Contract #: 04-0120F4Cty: SF/ALA Rte: 80 PM: 13.2/13.9File #: 69.25B**QUALITY ASSURANCE -- NON-CONFORMANCE REPORT****Location:** Changxing Island, Shanghai, P.R. China**Report No:** NCR-000640**Prime Contractor:** American Bridge/Fluor Enterprises, a JV**Date:** 18-Jan-2010**Submitting Contractor:** Zhenhua Port Machinery Company, Ltd (ZPMC), Changxing Island**NCR #:** ZPMC-0612**Type of problem:**

Reference Description: Perform of CWR repair on Lift 12 Longitudinal Diaphragm without following the approved procedure

Dear: Mr. Charles Kanapicki
Job Name: SAS Superstructure

Subject: NCR No. ZPMC-0612

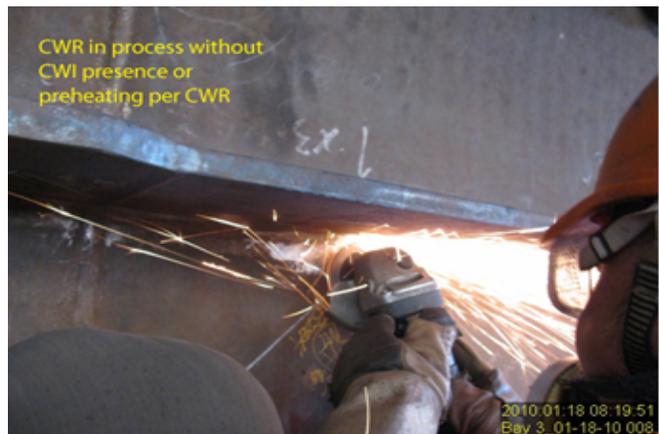
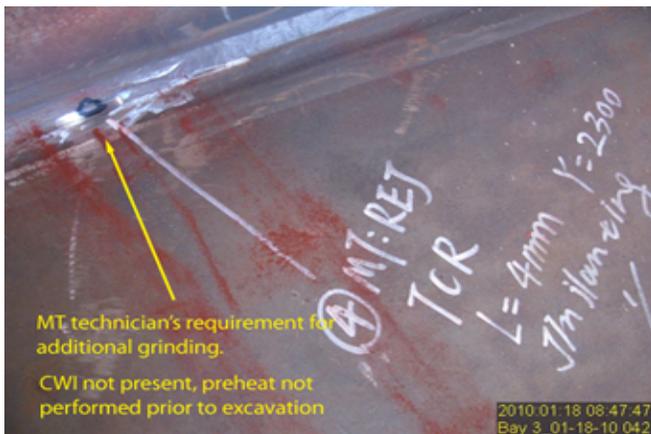
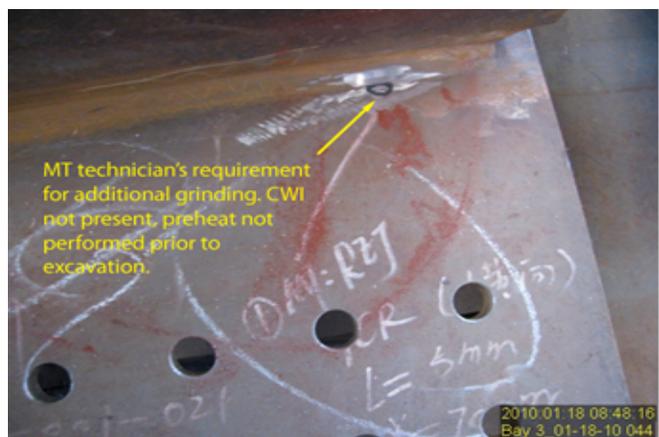
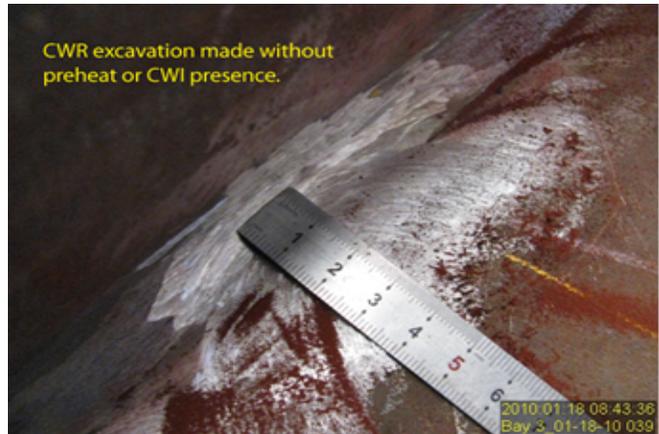
During random in process observations of the fabrication of the longitudinal diaphragms in subassembly, this Quality Assurance (QA) Inspector observed the following issues:

- ZPMC personnel were excavating Magnetic Particle (MT) Indications identified by ZPMC's MT Technician as cracks. The ZPMC worker did not have the approved Critical Weld Repair (CWR) B-1050 and B-1051 on hand during the repair.

- ZPMC Quality Control (QC) Certified Weld Inspector (CWI) was not present.
- ZPMC personnel were performing crack removal by grinding without preheat per these approved CWRs.

- Members are identified as LD3008-001 and LD3010-001.
- CWRs identified as B-CWR1051 for LD3008-001 and B-CWR1050 for LD3010-001 specify that QC CWI shall be present with the approved CWR in hand and preheat to 650 C prior to excavation by grinding.

- The following areas were being excavated:
 - LD3008-001; Weld 21; Y=75mm, Weld 14; Y=2300mm, Weld 08; Y=1100mm, Weld 07; Y=400mm, and Weld 06; Y=500mm.

- LD3010-001; Weld 49; Y=300mm, and Weld 43; Y=0mm.
- These welds are all fillet weld T-joints joining longitudinal diaphragm stiffeners to longitudinal diaphragm web plates.

Critical Weld Repair(s) B-CWR1050 and B-CWR1051; (1) “QC and a Lead CWI shall be present, direct and supervise all grinding and welding operations during this repair...” (2) “QC and Lead CWI shall have an approved copy of the CWR in hand prior to the repair.” (4) “...Preheat to a minimum 65degrees C before

Reference Description: ZPMC performed third time weld repair excavations to a SPCM weld without the Engineer's approval or an Critical Weld Report**Description of Non-Conformance:**

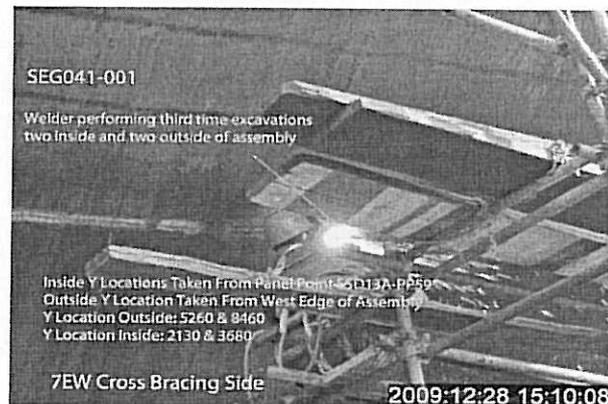
This QA observed ZPMC welding personnel performing third (3rd) time weld repair excavations to Seismic Performance Critical Material (SPCM) weld without the Engineer's approval or an Critical Weld Report (CWR) in the following four (4) locations:

- "Y" = 5260mm and 8460mm on the outside surface pulling from the west end of the segment.
- "Y" = 2130mm and 3680mm on the inside surface pulling from Panel Point 059.
- The Orthotropic Box Girder (OBG) segment is identified as 7EW.
- The weld is identified as SEG041A-001.
- The weld is designated as SPCM on the approved drawings.
- The weld is a Complete Joint Penetration (CJP) butt joint joining Side Panel identified as SP433A (SPCM) to SP101A.

Caltrans Special Provisions section 8-3.01 specifies In addition to the provisions in AWS D1.5, section 3.7.4 and section 12.17, third time repairs of welds, or base metal, regardless of NDT method,...require prior approval of the Engineer.”

Do not perform 3 time SPCM repair without notification and approval of a CWR. Submit UT test data to verify weld soundness.

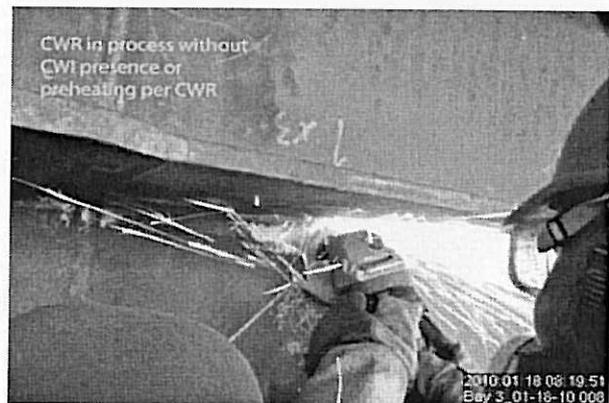
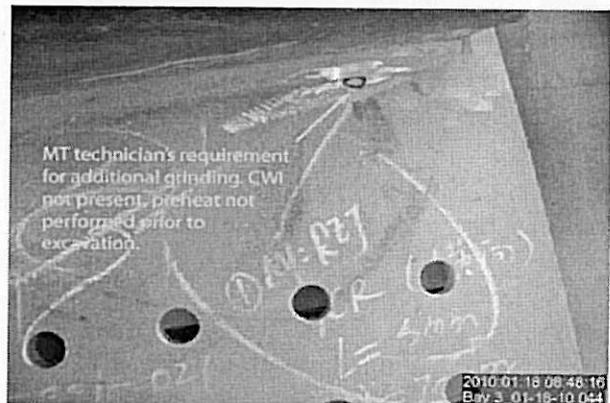
During random in process observations of the fabrication of the longitudinal diaphragms in subassembly, this Quality Assurance (QA) Inspector observed the following issues:

- ZPMC personnel were excavating Magnetic Particle (MT) Indications identified by ZPMC's MT Technician as cracks. The ZPMC worker did not have the approved Critical Weld Repair (CWR) B-1050 and B-1051 on hand during the repair.

- ZPMC Quality Control (QC) Certified Weld Inspector (CWI) was not present.
- ZPMC personnel were performing crack removal by grinding without preheat per these approved CWRs.

- Members are identified as LD3008-001 and LD3010-001.
- CWRs identified as B-CWR1051 for LD3008-001 and B-CWR1050 for LD3010-001 specify that QC CWI shall be present with the approved CWR in hand and preheat to 650 C prior to excavation by grinding.

- The following areas were being excavated:
 - LD3008-001; Weld 21; Y=75mm, Weld 14; Y=2300mm, Weld 08; Y=1100mm, Weld 07; Y=400mm, and Weld 06; Y=500mm.

- LD3010-001; Weld 49; Y=300mm, and Weld 43; Y=0mm.
- These welds are all fillet weld T-joints joining longitudinal diaphragm stiffeners to longitudinal diaphragm web plates.

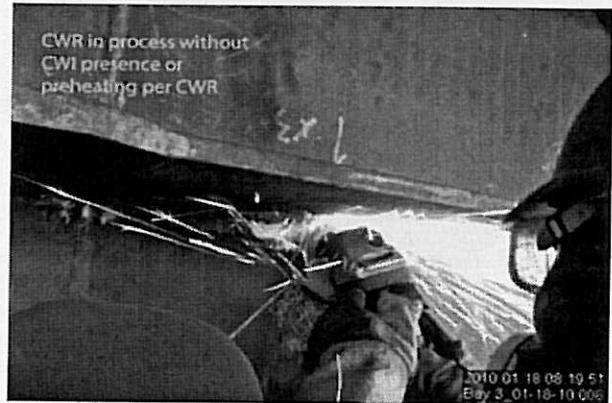
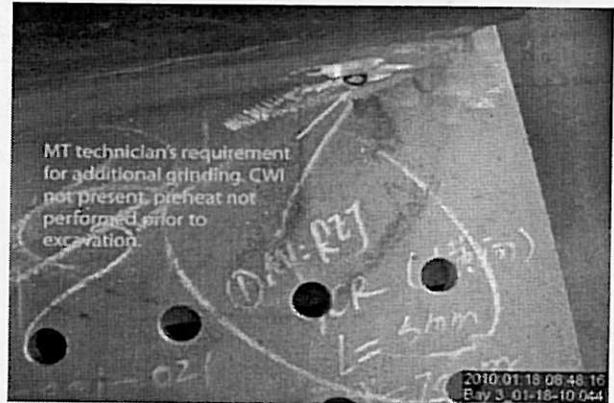
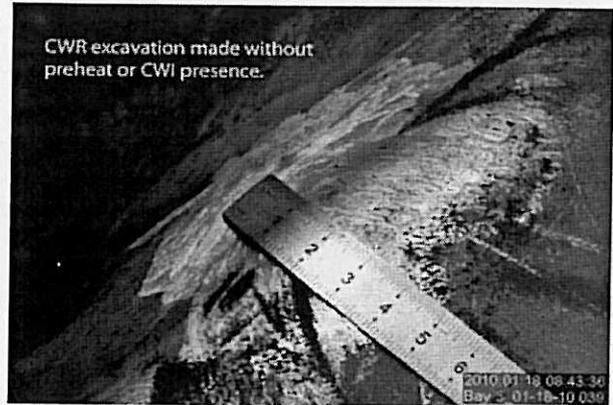
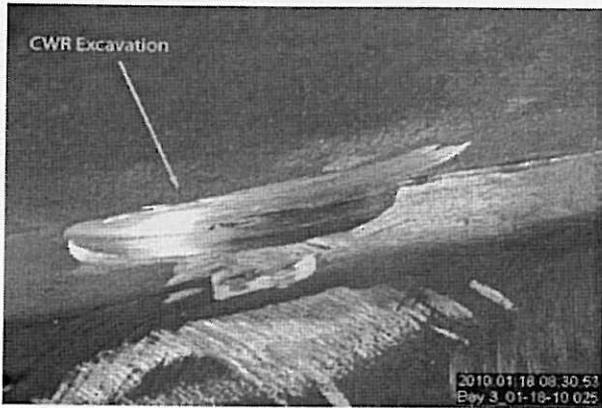
During random in process observations of the fabrication of the longitudinal diaphragms in subassembly, this Quality Assurance (QA) Inspector observed the following issues:

- ZPMC personnel were excavating Magnetic Particle (MT) Indications identified by ZPMC's MT Technician as cracks. The ZPMC worker did not have the approved Critical Weld Repair (CWR) B-1050 and B-1051 on hand during the repair.

- ZPMC Quality Control (QC) Certified Weld Inspector (CWI) was not present.
- ZPMC personnel were performing crack removal by grinding without preheat per these approved CWRs.

- Members are identified as LD3008-001 and LD3010-001.
- CWRs identified as B-CWR1051 for LD3008-001 and B-CWR1050 for LD3010-001 specify that QC CWI shall be present with the approved CWR in hand and preheat to 650 C prior to excavation by grinding.

- The following areas were being excavated:
 - LD3008-001; Weld 21; Y=75mm, Weld 14; Y=2300mm, Weld 08; Y=1100mm, Weld 07; Y=400mm, and Weld 06; Y=500mm.

- LD3010-001; Weld 49; Y=300mm, and Weld 43; Y=0mm.
- These welds are all fillet weld T-joints joining longitudinal diaphragm stiffeners to longitudinal diaphragm web plates.
